31 March 2006
Reference: 0043964
BYR 2006-025

Re: Notice of Modifications to Phase II Sampling
Former Yankee Nuclear Power Station
Rowe, Massachusetts

Figure 2- Summary of Monitoring Wells Status
Yankee Nuclear Power Station - Rowe, MA

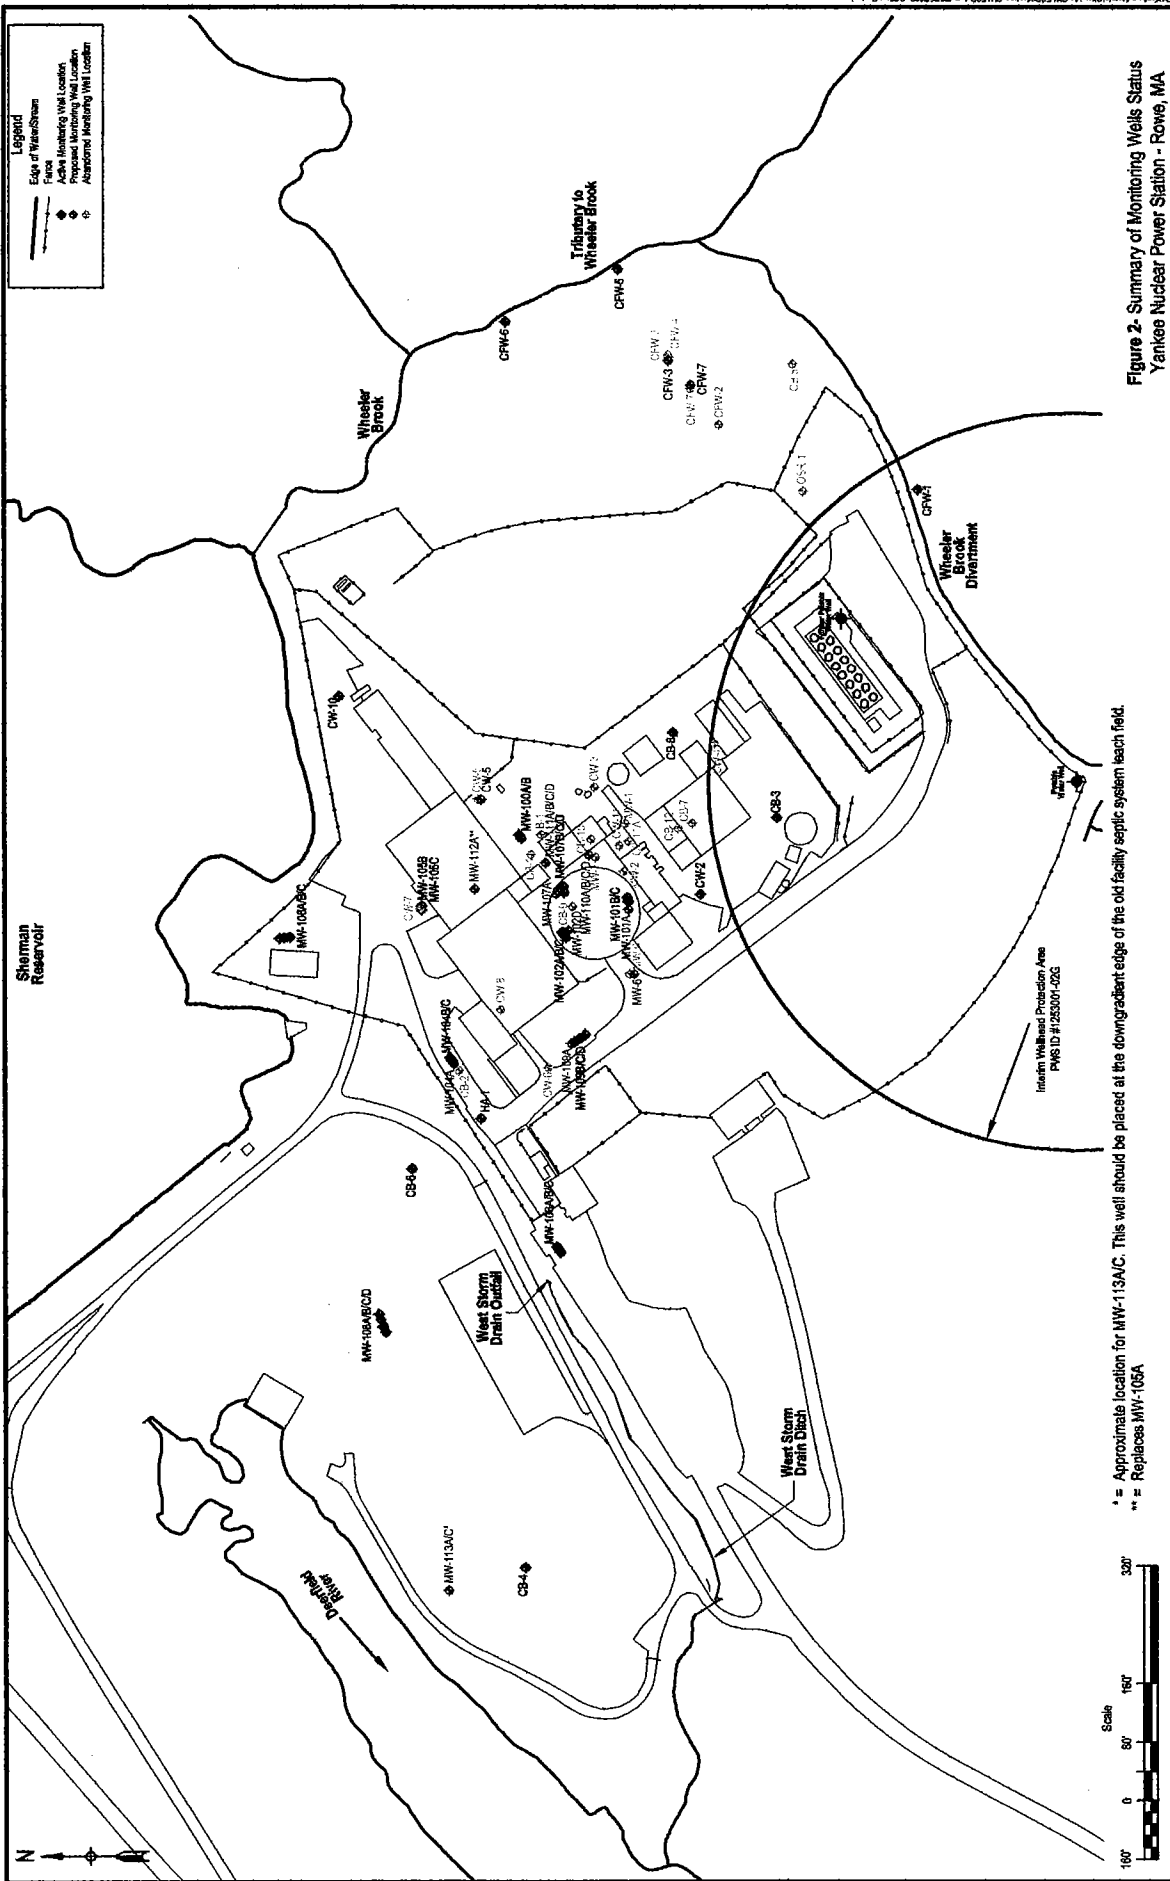
Groundwater monitoring for non-radiological parameters is planned for at least one additional quarterly sampling event in 2006. A summary of the groundwater monitoring program is provided in Table 2. Monitoring well locations are shown in Figure 2. As requested by the Department, all newly installed wells will be sampled for VOCs, PP13, and boron. In addition, select wells will be sampled for compounds of concern based on prior monitoring results and historic activities (i.e., samples from wells downgradient of the old septic field will be analyzed for SVOCs, EPH/VPH, and PCBs). The groundwater monitoring program includes reanalysis for parameters that exceeded the RC and any parameters requested by the Department that have not been previously analyzed.

The following monitoring wells are not currently planned for additional sampling and analysis because historic results are deemed to provide adequate testing for the parameters of interest (VOCs, PP13, and boron were previously analyzed) and none of the past monitoring results indicated levels that exceed applicable RCs: CB-6, CB-8, CFW-1, CFW-5, CW-2, MW-100A, MW-100B, MW-102A, MW-102B, MW-103A, MW-104B, MW-104C, MW-106A, MW-106B, MW-106C, MW-106D, MW-108A, MW-108C, Visitor Center Water Supply Well, and Sherman Spring.

* = Approximate location for MW-113A/C. This well should be placed at the downstream edge of the old facility septic system leach field.
** = Replaces MW-105A
